BAYVIEW HAVEN CANAL ESTATE

REPORT AND RECOMMENDATIONS

**ENVIRONMENT PROTECTION UNIT
CONSERVATION COMMISSION NT**

FIGURE 4

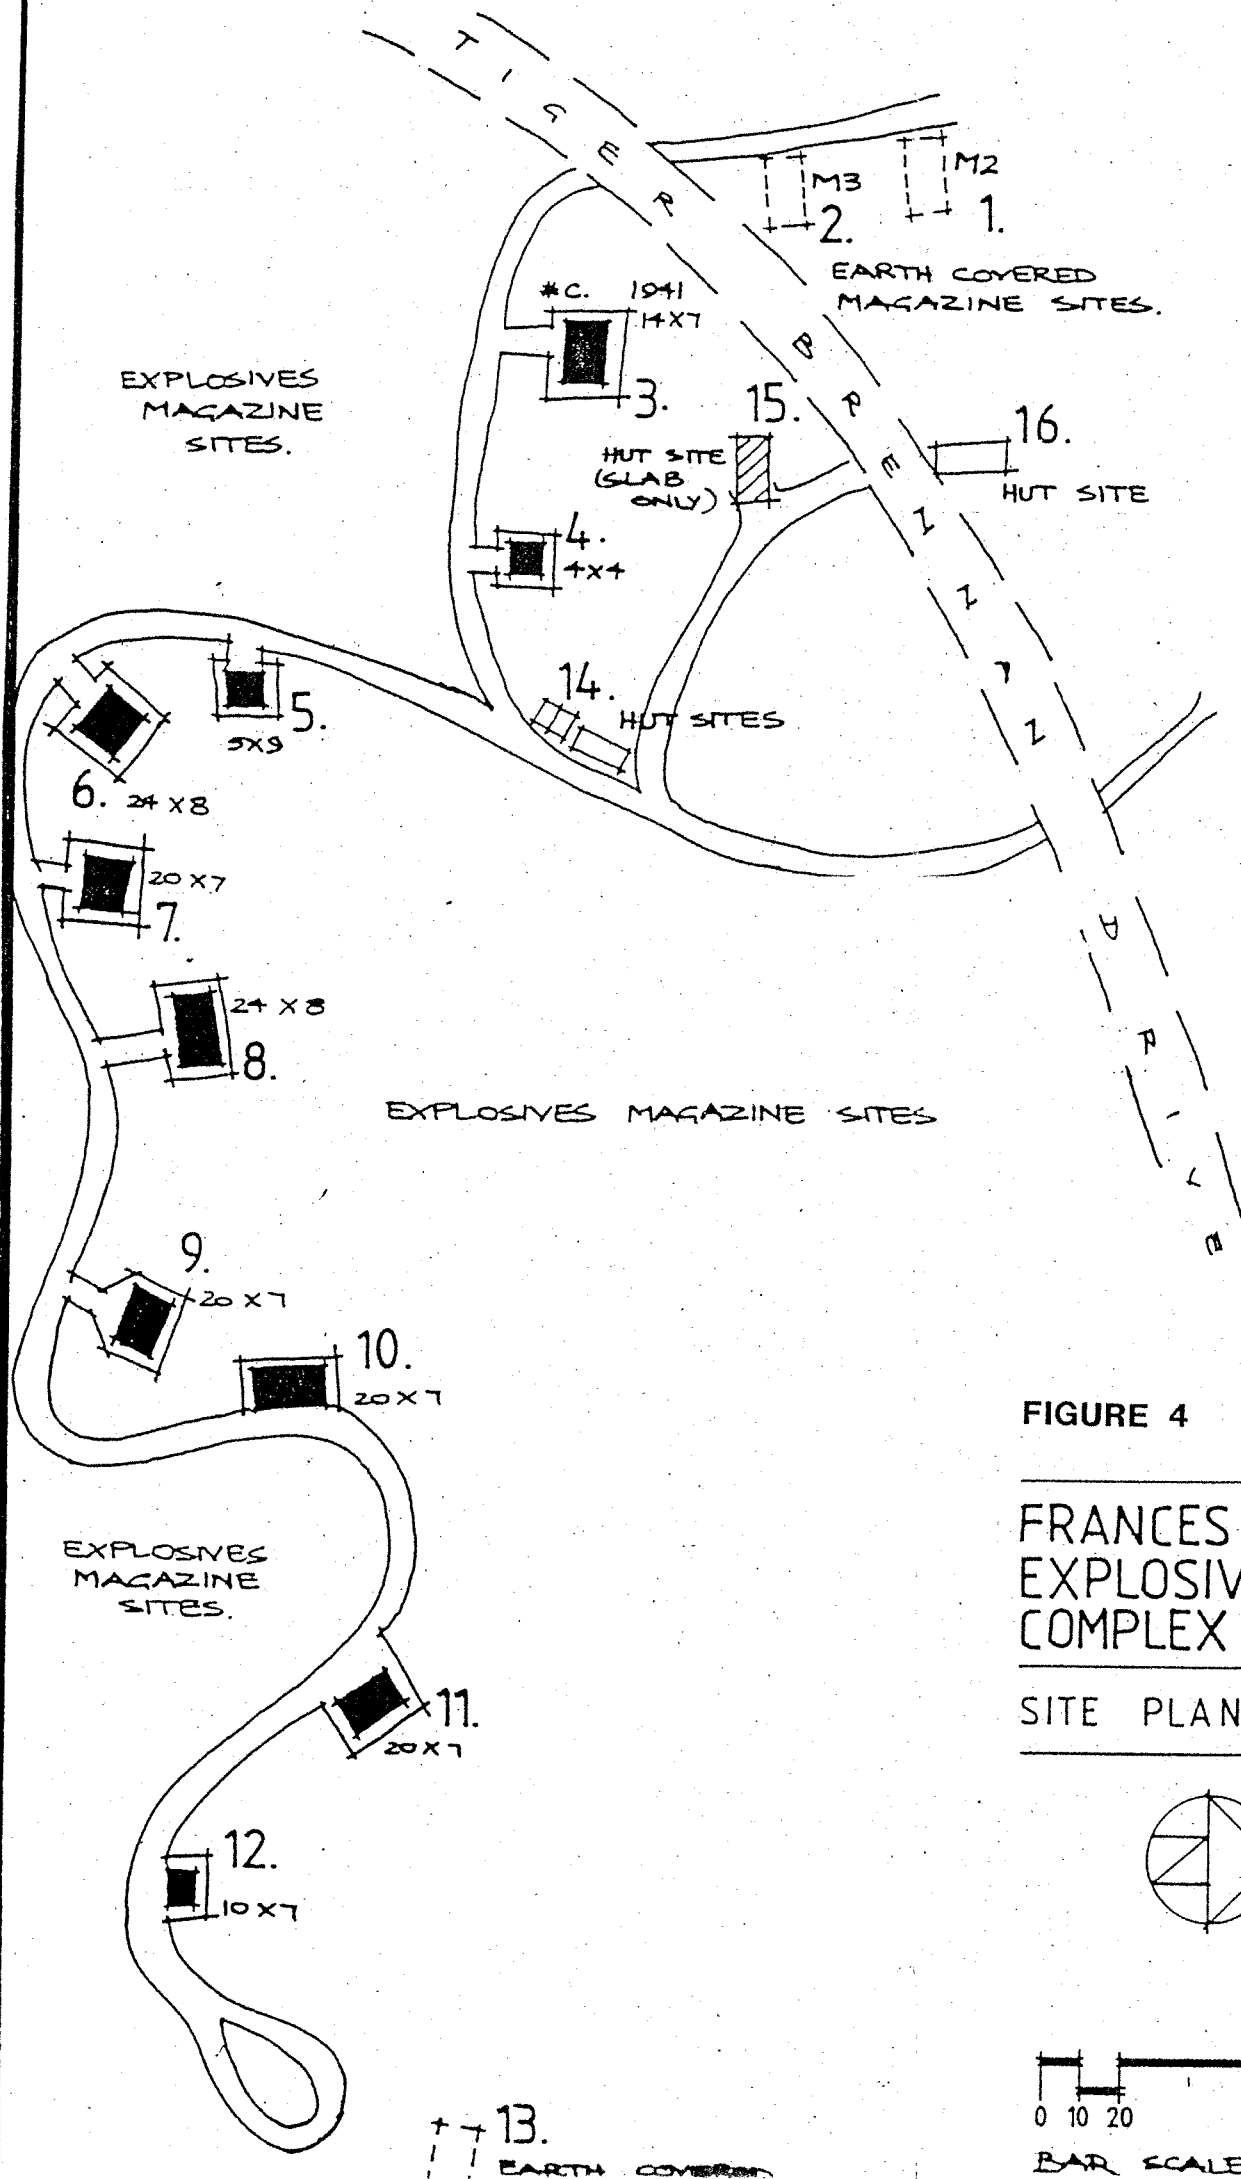
Review of the draft EIS indicated that the proposal to retain World War II heritage sites 3 and 4 (Figure 4) only was unacceptable for the following reasons:

Site 3 is within the railway reserve and is not part of the development. Its long term protection cannot, therefore, be guaranteed unless government is considerably constrained in its ability to utilise the railway reserve.

Site 4 is a minor storage, although relatively intact, and is located in the estate buffer strip. It would effectively be the only site offered full protection if the development proceeded as proposed in the draft EIS.

Site 6, and to a lesser extent Site 5, are considered to be the most valuable storages both in terms of their state of repair (Site 6 is relatively intact, Site 5 is less so due to recent vandalism), and significance of design and construction.

FIGURE 5 REVISED LAYOUT OF SUBDIVISION TO RETAIN HERITAGE SITES 5 AND 6

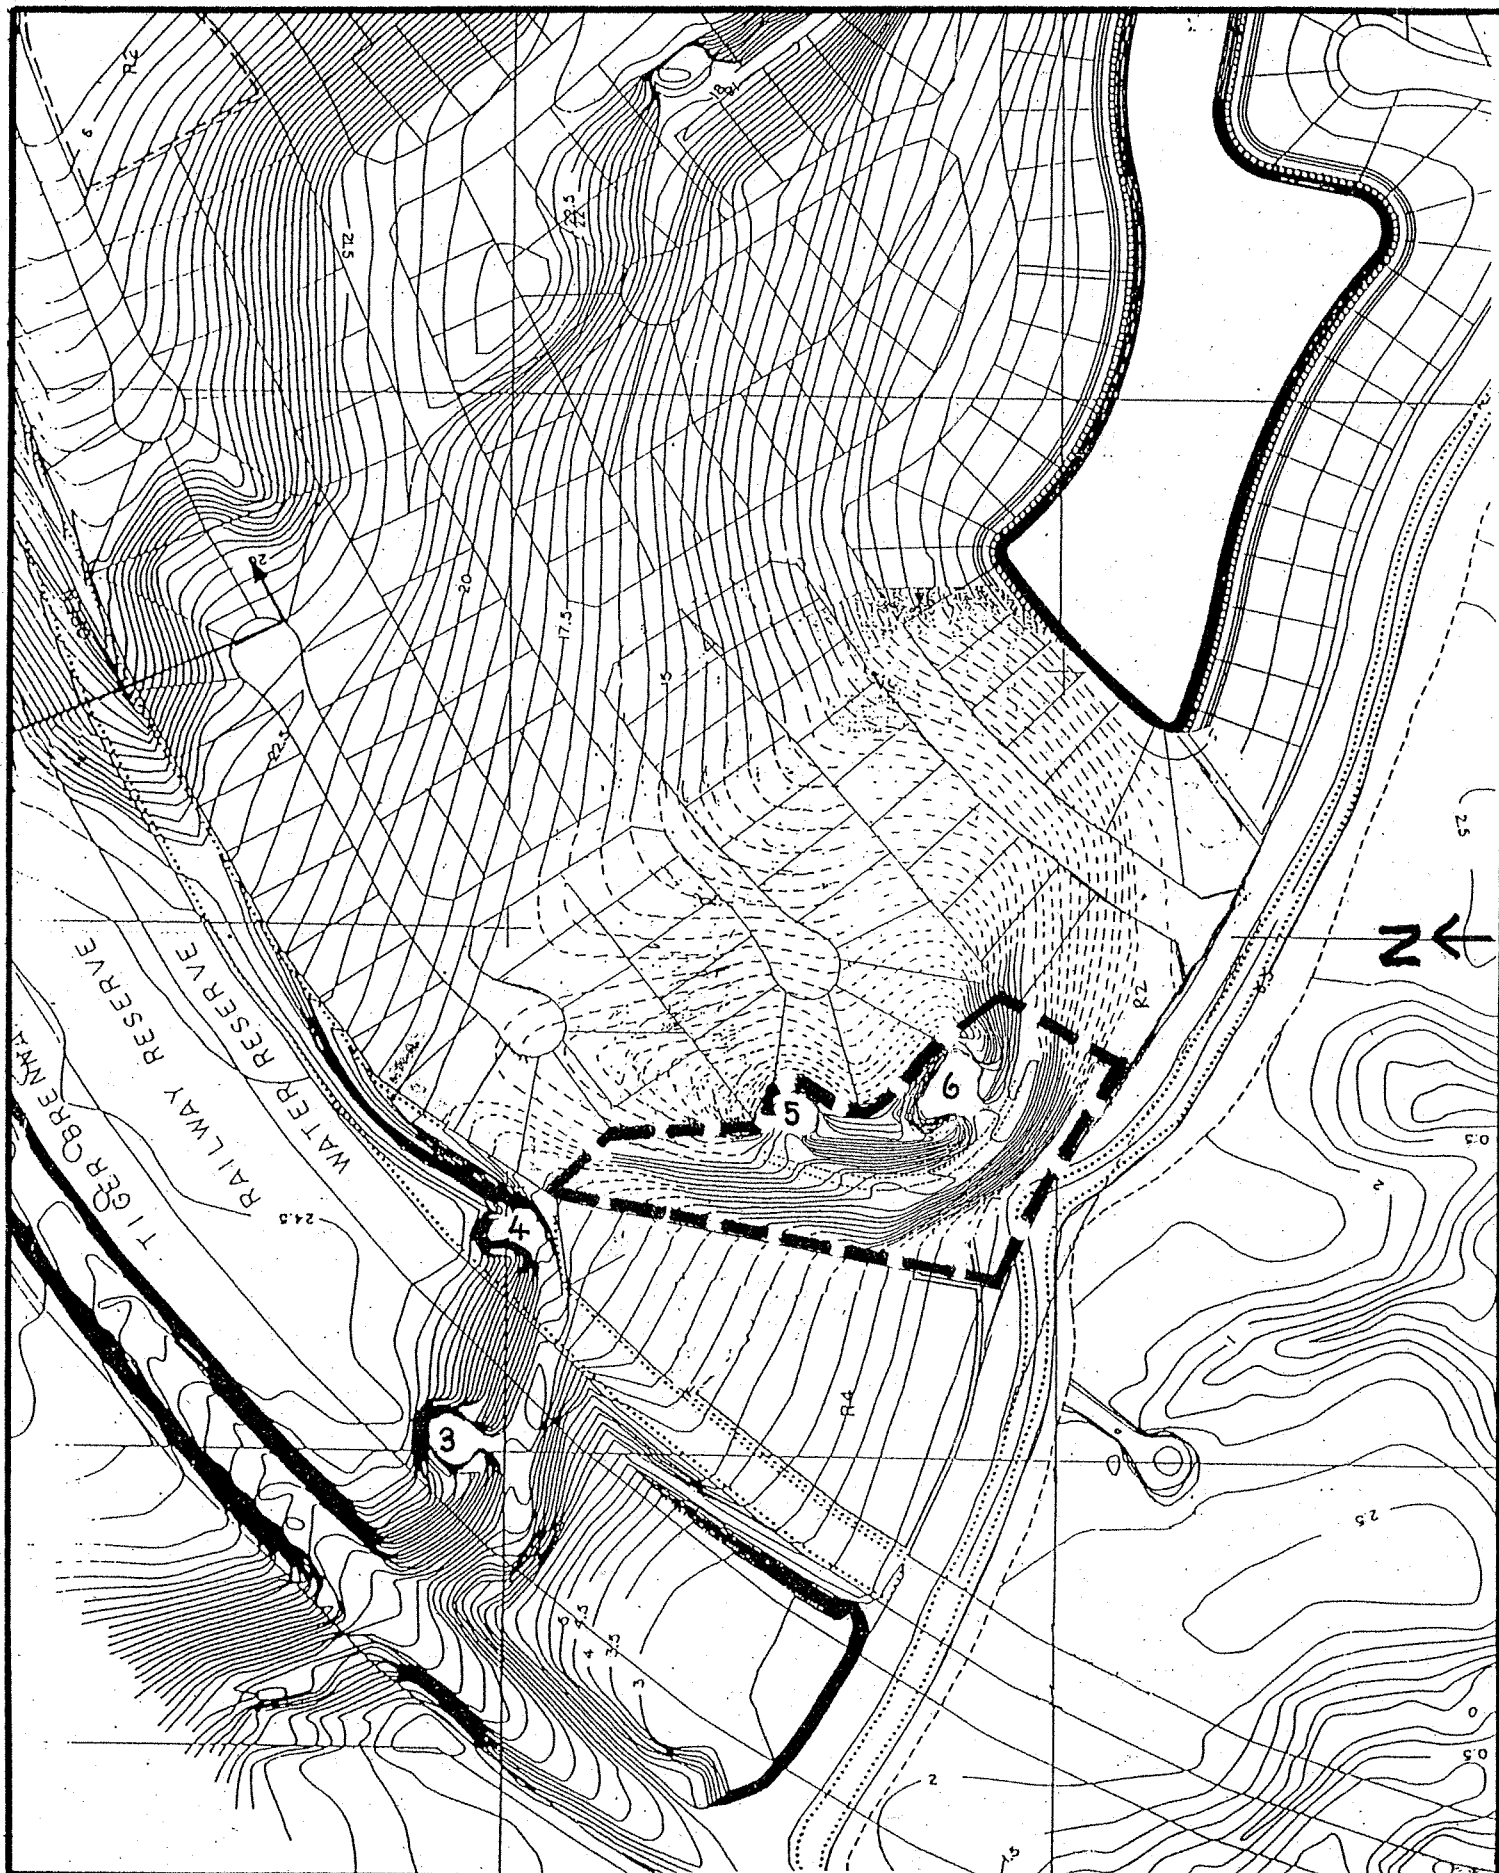
In the final EIS the proponent proposed a compromise whereby Sites 11 and 12 would be protected in a heritage precinct in addition to the retention of Site 4. This proposal was still unacceptable to the Commission's Heritage Unit as Sites 11 and 12 are in a state of ruin and not as significant as Sites 5 and 6 in terms of design and construction. In subsequent negotiations between the Commission and the proponent, the proponent agreed to the protection of Sites 5 and 6 in preference to 11 and 12, and a redesign of the subdivision layout (Figure 5).

The revised subdivision layout which retains heritage sites 5 and 6 be adopted in preference to the layouts presented in the draft and final EIS's.
